UNITED STATES PATENT AND TRADEMARK OFFICE

APPLICATION NO.	FILING DATE	FIRST NAMED INVENTOR	ATTORNEY DOCKET NO.	CONFIRMATION NO.
09/435,154	11/08/1999	SHUNPEI YAMAZAKI	SEL142	4834

Office Action Summary

FIG. 1

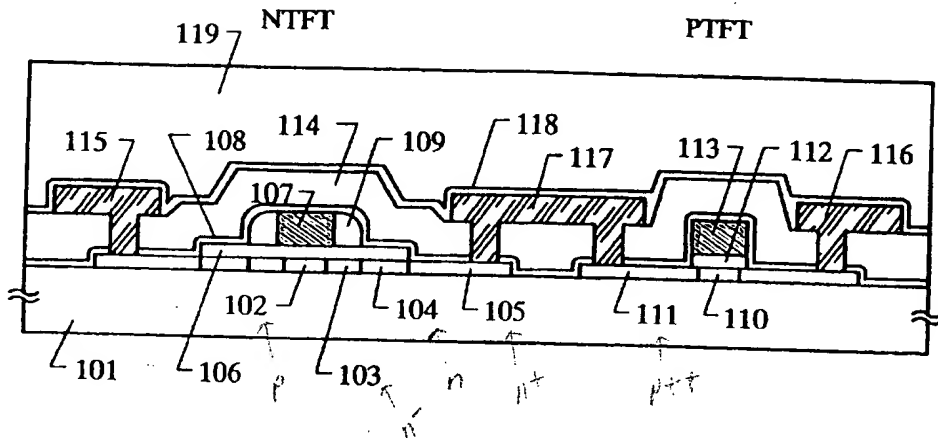
In regards to claims 1, 6, 14, 19, Yamazaki et al. disclose a goggle type display having a liquid crystal display (LCD) device having a CMOS circuit comprising an n-channel TFT and a p-channel TFT in figs. 1, 2A-5B, 12 and 13D. The CMOS circuit comprising: each gate electrode of the n-channel TFT and the p-channel TFT having a first conductive layer (the inner sub-layer of each of the gate electrodes [107, 113]) (see also the blue portion of each of the gate electrodes [107, 113] in Attachment A) being in contact with a gate insulating film [106, 112], and a second conductive layer (the outer sub-layer of each of the gate electrodes [107, 113]) (see also the red portion of each of the gate electrodes [107, 113] in Attachment A) being in contact with the gate insulating film and top and side surfaces of the first conductive layer; a semiconductor layer of the n-channel TFT comprising a first channel formation region [102], a pair of LDD regions [103] and first source and drain regions [105]; and a semiconductor layer of the p-channel TFT comprising a second channel formation region [110] and second source and drain regions [111], wherein a portion which the second conductive layer is in contact with the gate insulating film in the n-channel TFT partially overlaps the pair of LDD regions; wherein the portion which the second conductive layer is in contact with

It is inherent that each of the gate electrodes of the n-channel TFT and the p-channel TFT comprising a first conductive layer and a second conductive layer because a single conductive layer always comprises a plurality of sub conductive-layers. Therefore, Yamazaki et al. disclose a first conductive layer (the inner sub-layer of each of the gate electrodes [107, 113]) and a second conductive layer (the outer sub-layer of each of the gate electrodes [107, 113]) for each of the gate electrodes [107, 113] of the n-channel TFT (NTFT) and the p-channel TFT (PTFT).

It is urged, in page 11 of the remarks, that Yamazaki et al. contain no disclosure or suggestion of the alleged "outer" and "inner" sub-layers and there is nothing in Yamazaki et al. defining the boundary between the alleged outer sub-layer and the alleged inner sub-layer. However, as mentioned in the rejection and the Attachment A, it is inherent that each of the gate electrodes of the n-channel TFT and the p-channel TFT of Yamazaki et al. comprising a first conductive layer (the blue portion of each of the gate electrodes [107, 113] in Attachment A) and a second conductive layer (the red portion of each of the gate electrodes [107, 113] in Attachment A) because a single gate conductive layer always comprises a plurality of sub gate conductive layers. Therefore, Yamazaki et al. disclose a first conductive layer (the inner sub-layer of each of the gate electrodes [107, 113]) (the blue portion of each of the gate electrodes [107, 113] in Attachment A) and a second conductive layer (the outer sub-layer of each of the gate electrodes [107, 113]) (the red portion of each of the gate electrodes [107, 113] in

Attachment A) for each of the gate electrodes [107, 113] of the n-channel TFT (NTFT) and the p-channel TFT (PTFT). In addition, Yamazaki et al. further disclose the portion (the red portion of the gate electrode [113] in Attachment A) which the second conductive layer is in contact with the gate insulating film [112] in the p-channel TFT partially overlaps the second source and drain regions [111] as recited in the claimed invention.
